STAGECOACH NORTH VINEYARD CONVERSION EROSION CONTROL PLAN APPLICATION #P18-00446-ECPA

Final Environmental Impact Report State Clearinghouse #2019100250

Prepared for Napa County November 2022

Figure 3.3-6 Mitigated Proposed Project

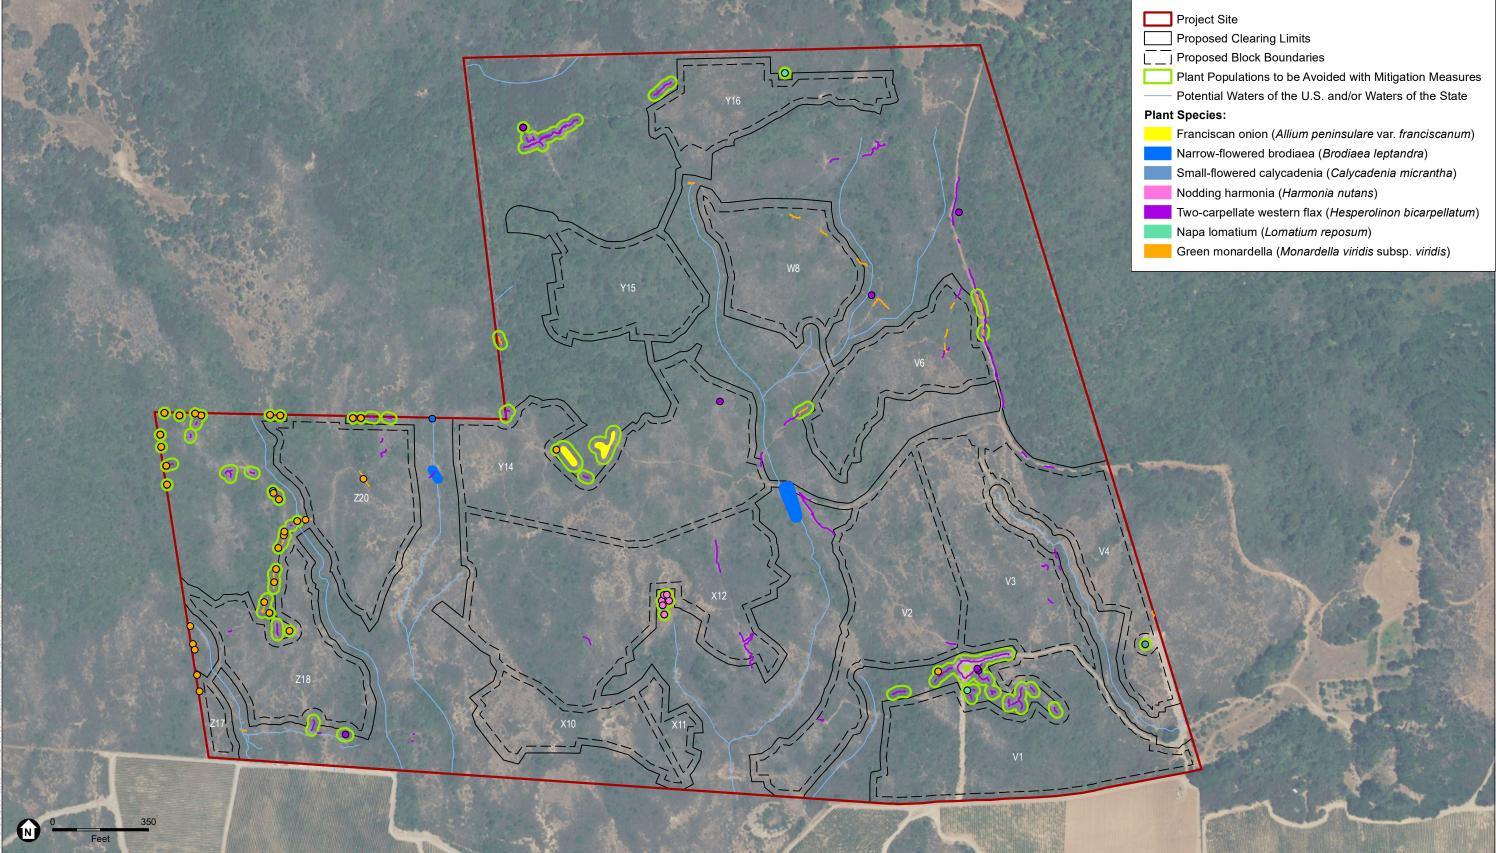
The Mitigated Project layout in Figure 3.3-6 did not take into account the infrastructure proposed in the ECP to ensure compliance with the County's policies requiring no-net-increase in runoff. The Mitigated Project layout requires avoidance of areas that contained multiple proposed detention basins, ditches, infield diversions, and pipelines. The Draft EIR states that the Mitigated Project would allow planting of 69.0 net acres in 90.5 gross acres cleared; this overstates the potential plantable area because the infrastructure that was impacted by the avoidance areas would need to be relocated within the remaining areas allowed to be developed.

The Draft EIR does not disclose that the Mitigated Project cannot be built as depicted in Figure 3.3-6 because it does not comply with the County's policy requiring no-net-increase in runoff. PPI Engineering has been working diligently during the public comment period of this Draft EIR to attempt to redesign the project within the Mitigated Project's outer clearing limits to meet the no-net-increase-in-runoff standard. Fortunately, we have been successful in mitigating potential

Numerous measures in the Draft EIR require avoidance of all or portions of vineyard blocks, and Figure 3.3-6 in the Draft EIR includes a mitigated deer fence layout around the Mitigated Project footprint. The total length of the mitigated deer fence is 33,941 feet whereas the original proposed deer fence was 8,527 feet, representing an almost four-fold increase in the amount of fencing that would be required. This large increase in the amount of fencing greatly increases the cost of project construction, but more importantly the mitigated deer fence required by Mitigation Measure 3.3-4 creates wildlife entrapment risk and undermines the County's goal of improving wildlife movement corridors.

Figure 3.3-6 does not depict the existing deer fence in the vicinity and therefore does not accurately portray existing or proposed site conditions. There is an existing deer fence that follows the majority of the southern property line of the Stagecoach North parcel; the segment that deviates from the parcel line to border existing vineyard on the southern parcel still creates a complete barrier to wildlife movement in the north to south direction. As mentioned above, Figure 3.3-6 does not show this existing fence and the aerial photo view is cut off to the south, creating the impression that a wildlife corridor is present that extends off the property to the south. Such a corridor does not actually exist.

We request that the County amend Figure 3.3-6 and Mitigation Measures 3.3-1a through 3.3-1i as necessary to allow higher levels of impact in the northern portions of Block Z18, northern portions of Block Y14, and eastern portion of Block Y16, and increase the mitigation replanting ratios as appropriate.

Figures 3.3-6 (*Mitigated Proposed Project*), 3.3-7 (*Special-Status Plant Species Avoided with Mitigation Measures*), 5-1 (*Increased Preservation Alternative*), and 5-2 (*Increased Watercourse Setbacks Alternative*) are revised to add back in proposed Detention Basin #2 in Block Y16 (approximately 0.4 acre). The mitigated wildlife exclusion fencing was also updated on Figure 3.3-6 and the existing fencing was added to this figure. Colored shading was also added to Figures 5-1 and 5-2 to clarify the mitigation areas removed (green shading) and the additional areas removed due to the alternative (pink shading).

- **O3-5** The comment about the increase in the total length of the mitigated deer fence is noted. In response, the County has revised the wildlife exclusion layout in Figure 3.3-6, taking into consideration the existing wildlife exclusion fencing located along the southern boundary of the project site. The existing wildlife exclusion fencing shown on Draft EIR Figure 2-4 has also been added to Figure 3.3-6 (see Final EIR Chapter 2). To further protect avoided/undeveloped areas enclosed by wildlife exclusion fencing as a result of mitigation, a new component has been added to Mitigation Measure 3.3-4 (see Final EIR Chapters 2 and 4).

The County has also revised the wildlife exclusion layout in Figure 3.3-6, taking into consideration the existing wildlife exclusion fencing along the southern boundary of the project site. A new component has been added to Mitigation Measure 3.3-4 to further protect avoided/undeveloped areas enclosed by wildlife exclusion fencing as a result of mitigation. See Final EIR Chapter 2, *Revisions to the Draft EIR* and Chapter 4, *Mitigation Monitoring and Reporting Program* and Responses to Comments O6-18 and O3-5.
